PRODUCT CHANGE NOTIFICATION

Product Identification: 0ZCGXXXXXXXX, 0ZCHXXXXXXXX, 0ZCKXXXXXXXX

PCN Number: PCN-F250027

Marking example:

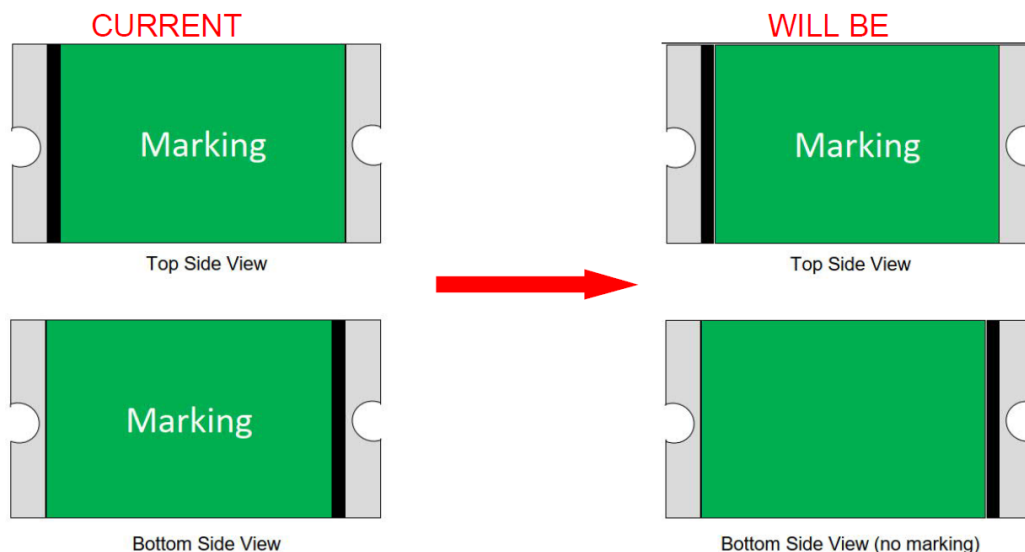
Description of the Change (s): 0ZCG,0ZCH, 0ZCK Series change the product marking from "double-sided marking" to "single-sided marking". The no-marking side is intended to improve soldering performance.
